1 PROPOSED GROUND FLOOR PLAN - OPTION B
Scale: 1:100

No.	Date	Issue Notes
Project ID		2502
Project Title		COMMERCIAL WAY, WOKING
Sheet Title		PROPOSED GROUND FLOOR PLAN
Date		25/01/2026
Scale		1:1
Sheet No.	Rev. No.	
020 B

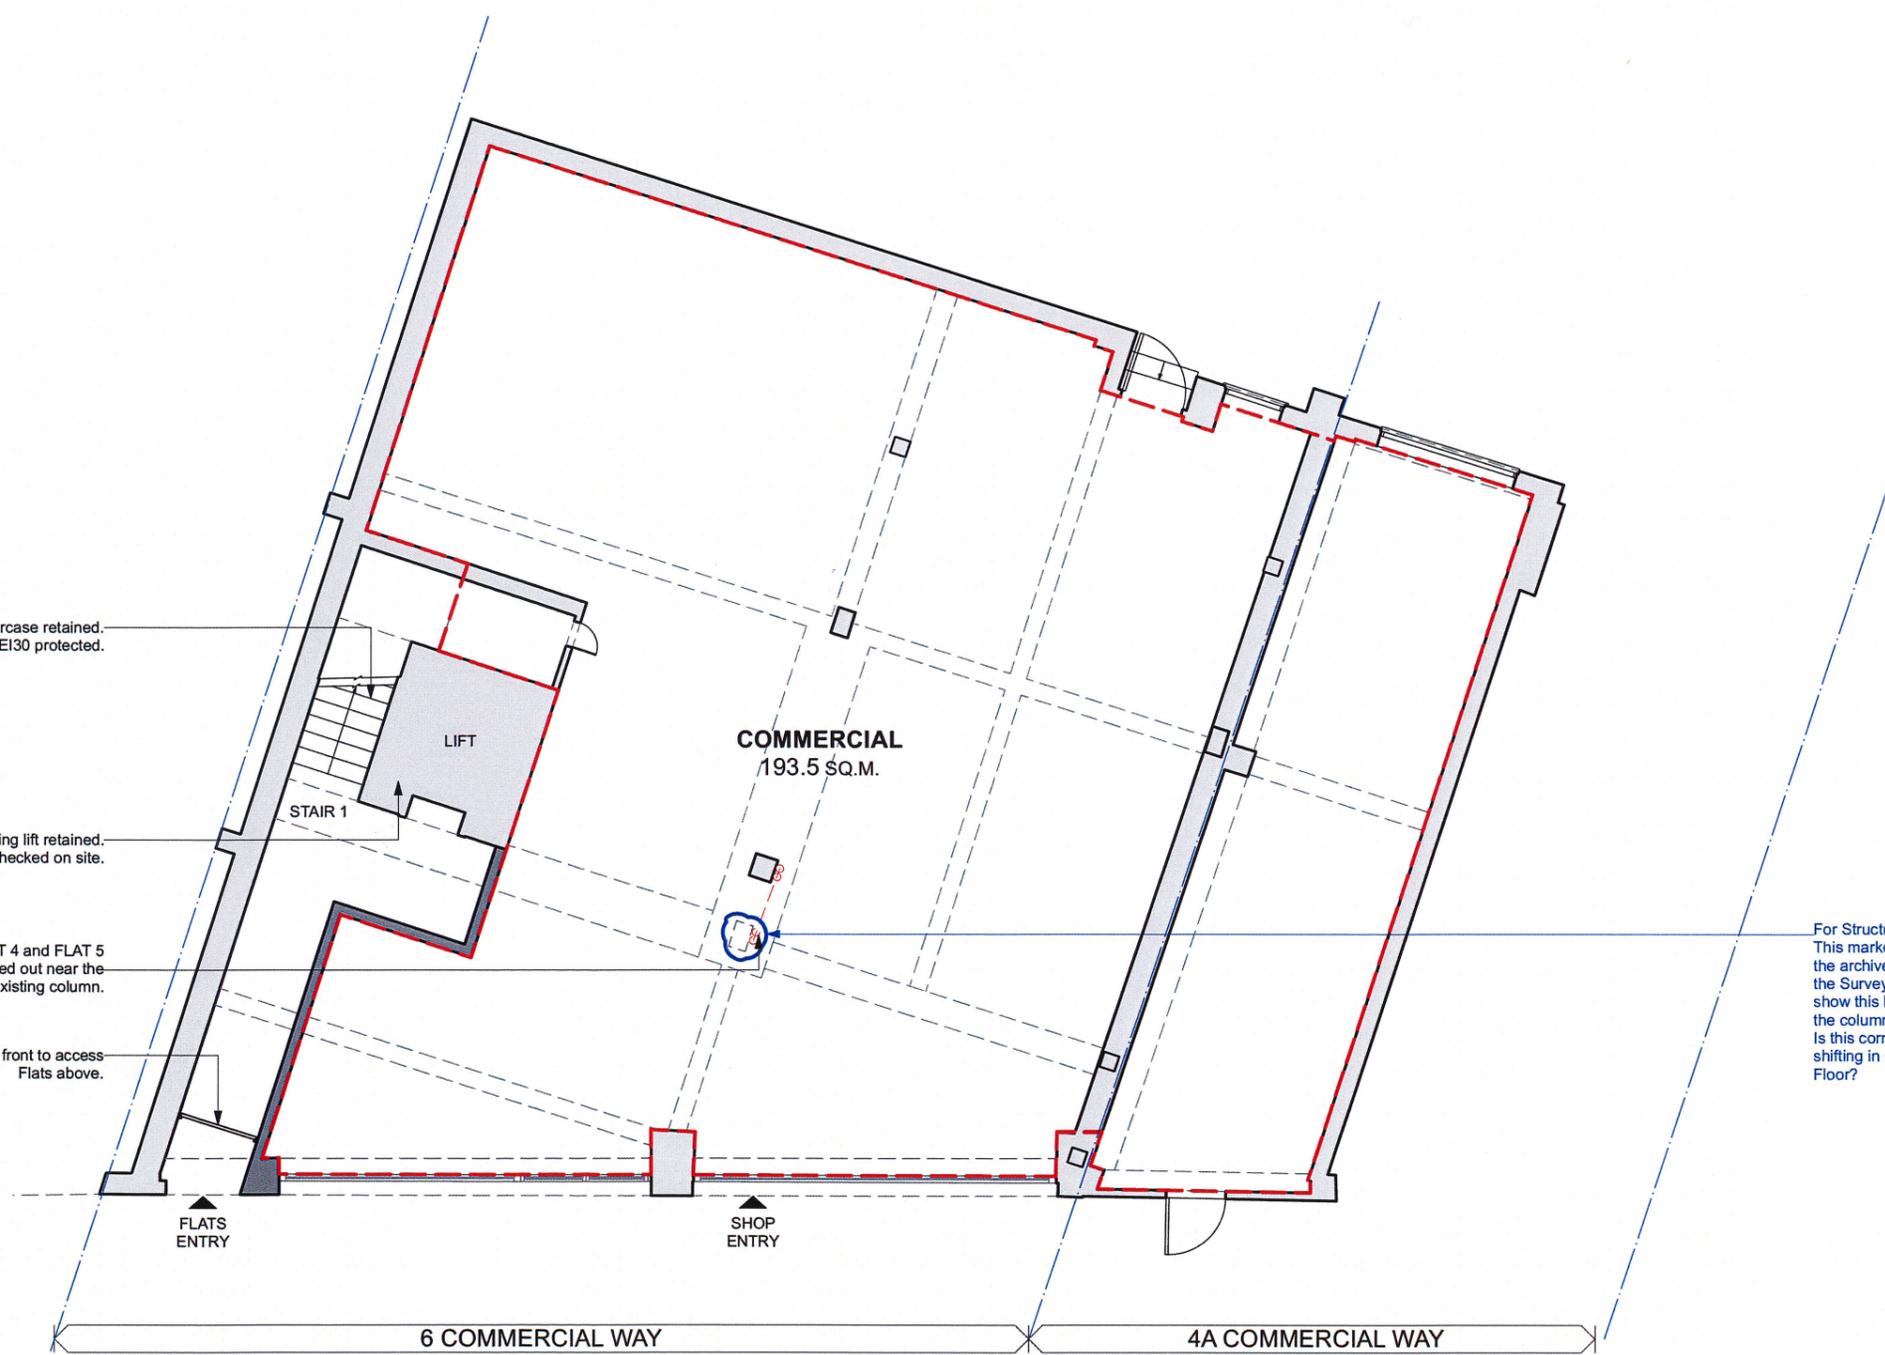
Existing staircase retained.
Staircase to be REI30 protected.

Existing lift retained.
Lift to be checked on site.

SVP from FLAT 4 and FLAT 5
above to be boxed out near the
existing column.

New door to the front to access
Flats above.

For Structure Engineer:
This marked column is shown in
the archive and in First Floor. But
the Survey drawing does not
show this here. It is replaced by
the column above this.
Is this correct/possible? Column
shifting in Ground and First
Floor?
